**Flood Control Project Maintenance
Levee Inspections**

Maintenance Issue Types Only, Levee Inspection Report By Mile - Spring 2018

Sutter Maintenance Yard Maintenance Area 0013

Waterway	Bank	Unit Miles	Inspection Start/End	Inspector
Unit No. 01 Cherokee Canal	Right	18.19	04/17/2018 04/17/2018	Bob Duffey

Photo 3 of 3 : UCIP_SP_2018_52238_66967.jpg

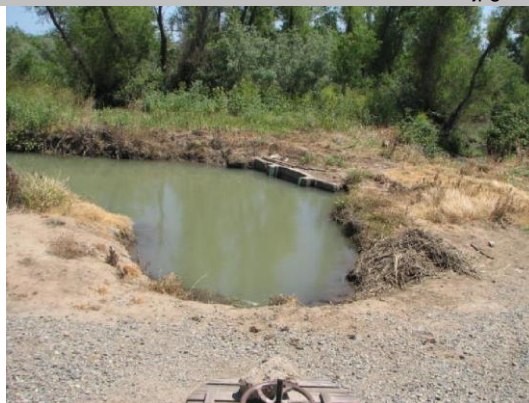
Item	DWR UCIP LMA Responsibility			39.420667 °	39.420667 °	
				-121.775700 °	-121.775700 °	
DWR ID						
Comment Code						
Inspector Comment						
FS_ID:52238 DS_ID:16337 EP_NO: N/A Repair Type: No Action Needed Crossing Status: Found UCIP Comments: 6/15/2017 Crossing appears to be in good condition. Pipe has been selected to be internally cleaned and inspected as part of the DMP project. (DWR Sutter Yard- A Freitag)11/17/2016 Ws pipe end was submerged but crossing appears to be in good condition. (DWR Sutter Yard- A Freitag)5/03/2016 Crossing appears to be in good condition.7/13/2015 New screwgate installed inside of WS standpipe.5/21/2014 Same as last inspection.12/3/2013 Same as last inspection.7/15/2013 Same as last inspection. FIELD_STRUCT_DESC: 24-inch corrugated metal drainage pipe through the levee, 11.1 feet below the crown. Slide gate in corrugated metal pipe (CMP) riser on the waterside (WS) slope. Concrete "U" headwalls on both ends. [Additional Reference(s): DWR Levee Log, 1993. USACE Sacramento O&M Manual 519, June 1962 (HLM 13.53)] FS Date: 6/19/2017 1:33:59 PM

Photo 1 of 1 : SP_2018_MA0013_300_61_20180305_00011.jpg

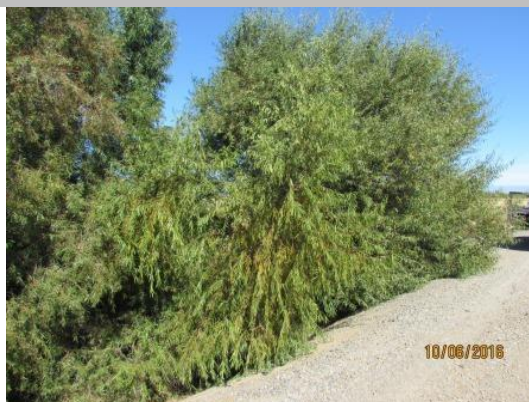
LM Start	13.76	Rating **	U	Issue No.	61
LM End	13.76	Issue Type +	Ma	Location *	LS
Category	Earthen Levee			GPS Latitude/Longitude	
				Start	End
Item	Trim / Thin Trees			39.416854 °	39.416854 °
				-121.781855 °	-121.781855 °
DWR ID	DWR_MA0013_01_f_2016_61				
Comment Code					
T1 : Trim trees to at least five feet above ground level.					
Inspector Comment

Photo 1 of 3 : UCIP_SP_2018_52121_67094.jpg

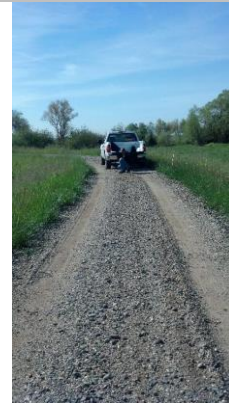
FIELD_STRUCT_DESC: "ABANDONED" 36-inch corrugated metal drainage pipe through the levee, 11.5 feet below the crown. Concrete "U" headwalls located on both the waterside (WS) and landside (LS) ends. Flap gate on the WS end. Slide gate on the LS end. [Additional Reference(s): DWR Levee Log, 1993. USACE Sacramento O&M Manual 519, June 1962 (HLM 3.61)]
